Subject: RE: Encroachment Permit 990 San Pablo Avenue, Albany, California

The City of Albany has requested that the borings for RO2974, in the City right-of-way be moved as shown in the attached PDF. The proposed work and the locations of the proposed borings were approved following a meeting with Dilan and Barb, so we would like confirmation that the changes requested by the City of Albany are acceptable with you and your department.

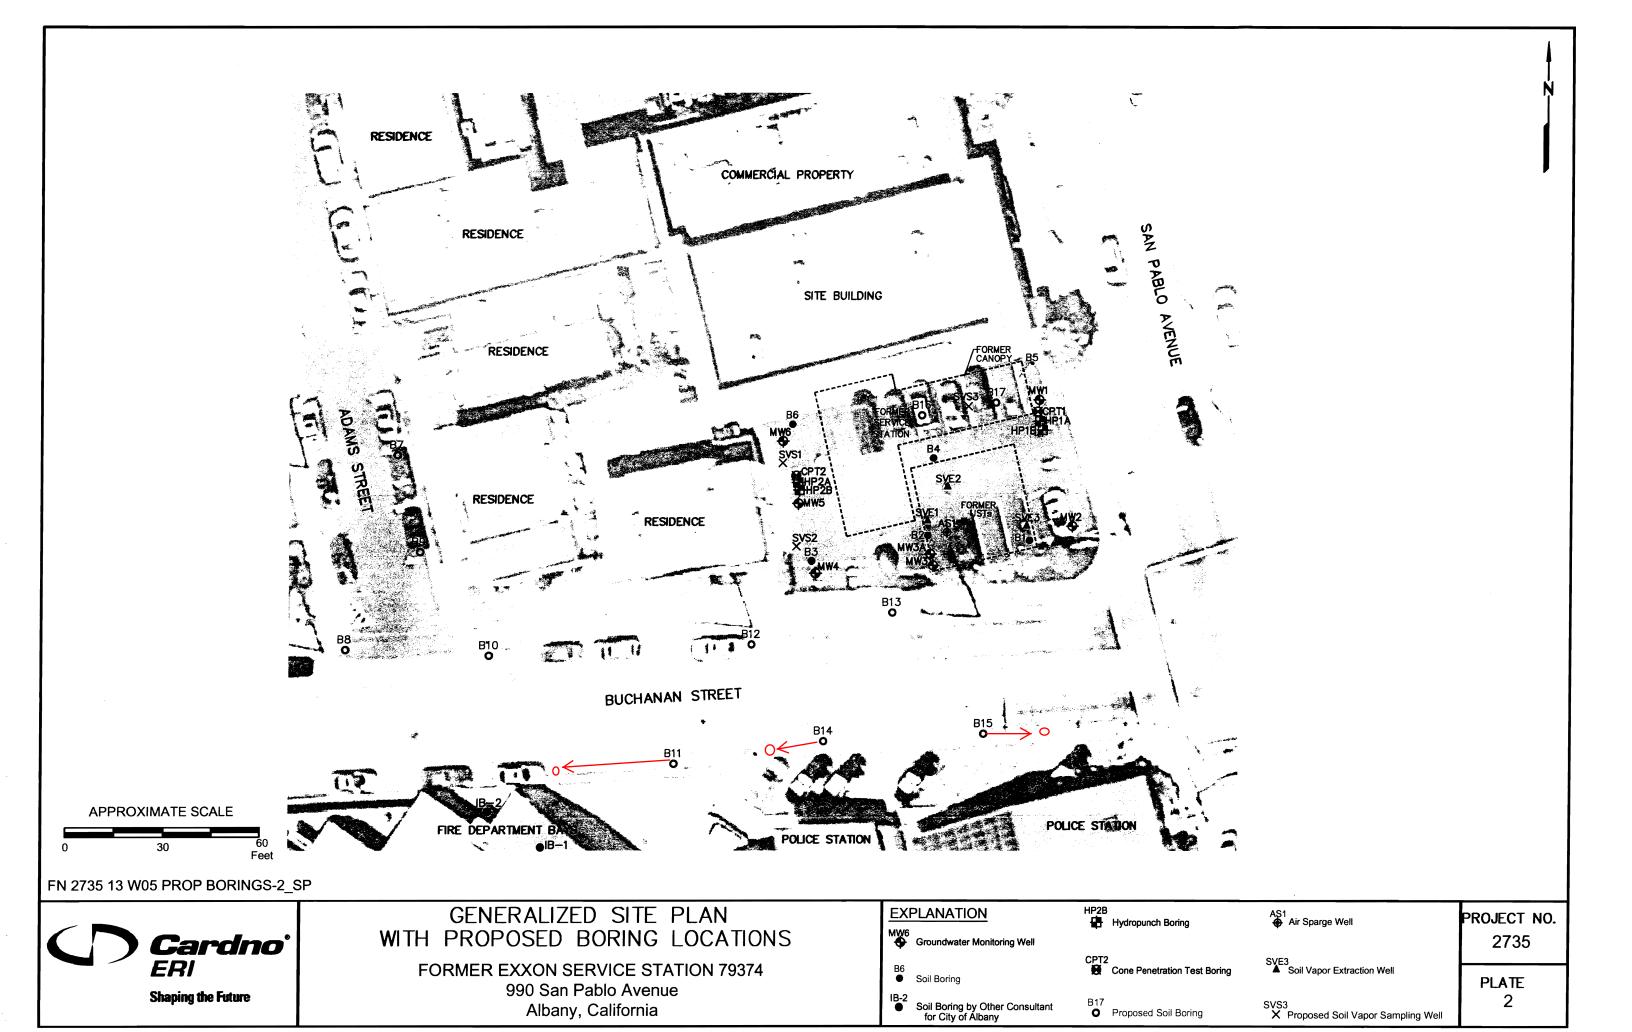
From what I can determine the original locations of the soil bores were evenly spaced in order to collect data to determine the extent of soil and groundwater across Buchanan from the former Exxon station. Also, from what I can determine, the City appears to have asked that the bores be moved out of the access drives for both police and fire station emergency vehicles along the south side of Buchanan Street.

Second – If this is correct, can soil bores B14 and B15 be moved just outside the "Keep Clear" street markings than where you have them depicted (closer to the original proposed locations to minimize movement and keep bore spacing approximately the same), or have they been moved further on purpose?

Third – You should be aware that the fire station also has a former UST and investigation very close to the new location for B11; see RO297 for recent work plans and addendum maps (I've attached the addendum). You may want to evaluate the appropriateness of the location. Be aware, the bore location and data is older.

I am looking at the referenced encroachment permit and three of the proposed soil boring (B11,B14, and B15) will be affecting the operations of the Fire Department and Police Department due to its location right at the entrance of their driveways. I was wondering if there is a way to slightly relocate these borings to the proposed locations and away from their emergency exit as shown on the attached PDF. This would expedite the process and would not cause any problem to their operation.

From what we can determine, we don't think there is much of a choice on the locations. Because you have been limited by the city, the locations will need to be satisfactory. I only ask that they be moved the minimum possible.

We are aware that the Fire station is an active case and that they had borings near B11. Given that the City has designated this a "clear zone" they probably had to drill there, for the same reason.
